**RE: Nolte Pit #1  
Permit # M-2012-016**

The purpose of this letter follows our receipt of your April 12, 2018 correspondence to us regarding the Nolte Pit, File No. M-2012-016, Technical Revision (TR-3) Adequacy Review. We have identified your questions/concerns as follows and accordingly have responded, in bold following each concern/questions. Please note the following:

**RE: Nolte Pit #1**  
**Permit # M-2012-016**  
**Technical Revision Submittal #3**

Reclamation Plan Update  
for 2018

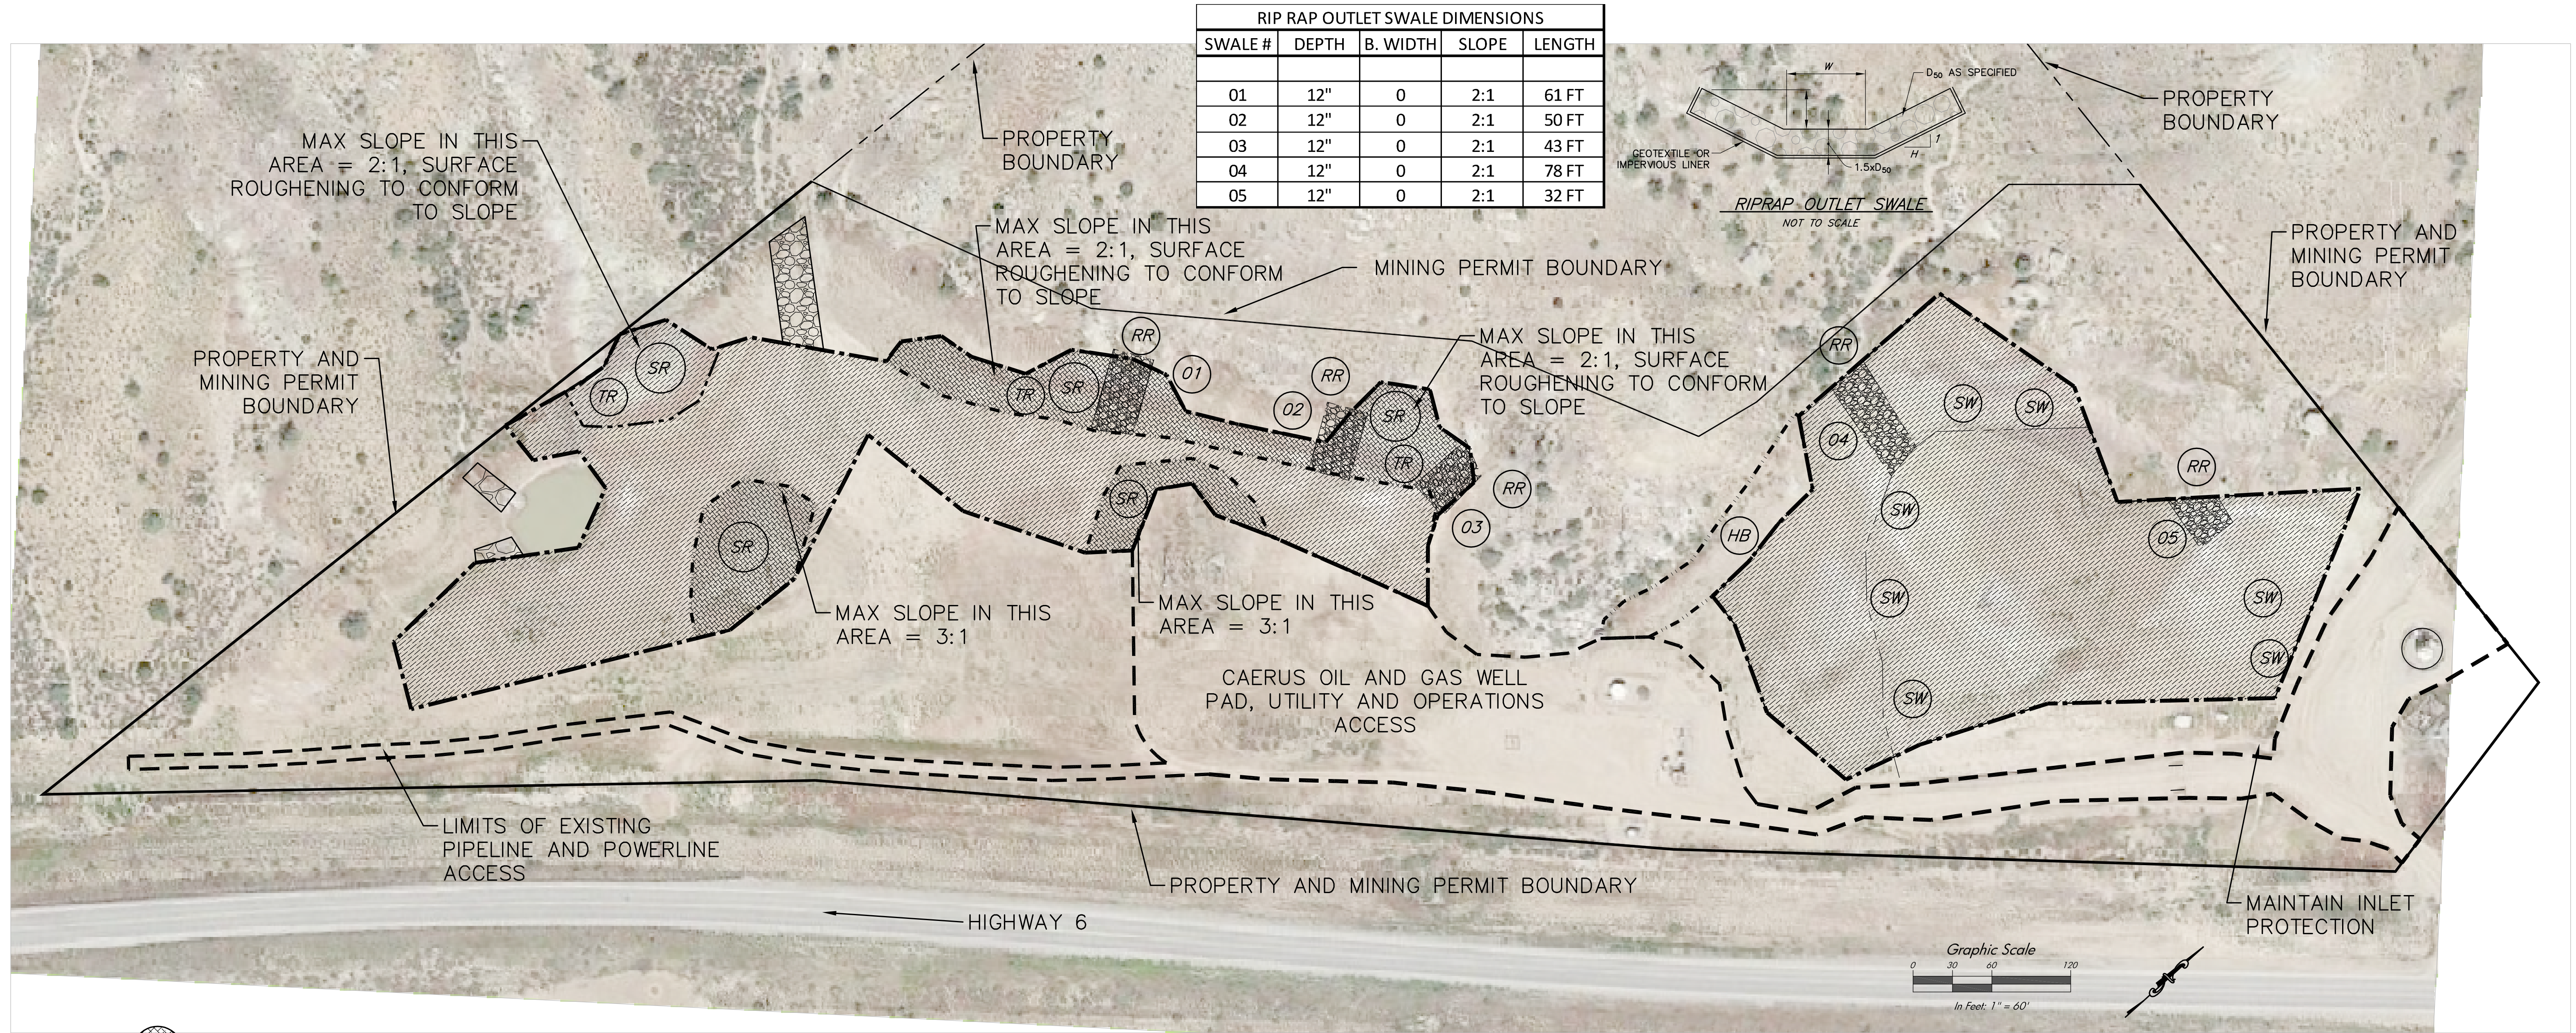
- Please state the revised seed mix in the narrative portion of your reclamation plan. The seed mix listed in the original submission differs from that posted on the reclamation map rev. 4/5/2018

- Note that seeding rates will be doubled for all methods other than drill seeding

- On the reclamation plan map rev. 4/5/2018 the Application Methods Table

- No acreage is given for areas to be Drill Seeded

- No acreage is given for those areas to have Wood Cellulose Fiber mulch applied

- Under fertilizers a significantly larger area is stated to be hand spread than previous versions, does this mean areas that aren't going to be seeded will also be fertilized?

- Based on the narrative portion of this revision the entire area will be fertilized/soil amendments applied hydraulically, however the table indicates that only a small portion will utilize this method.

- On the reclamation plan map rev. 4/5/18 the straw waddle placement is based on the attached CDOT specs however no specs were included. Also rather than using a generic 50' spacing of waddles, horizontal placements should determine by slope.

- Rip-Rap channels;
  - Please provide a cross section detail

- A table summarizing each channel that includes the followings; length, depth, width bottom, and slope (X:1)

**The narrative portion of the reclamation plan has been revised.**

**The seeding rates have been adjusted such that the methods other than drill seeding are doubled. This is noted in both the narrative and on the plan.**

**No drill seeding is proposed.**

**Table on the reclamation plan has been adjusted. The bare areas in the flat that are to receive seed and fertilizer are to be receiving such. Acreage is 0.17 ac.**

**This has been modified to match other surface treatments to make sense. A fertilizers will be applied using hydro spreading. Acreage is 1.02 ac.**

**Clarified in both narrative and on plan.**

**Drawing has been adjusted to reflect that waddle placement to be per CDOT requirements based upon slope.**

**A cross section detail has been provided on the drawing.**

**A table has been provided on the drawing and a noted area next to each rip rap channel has been identified to cross reference to the table.**
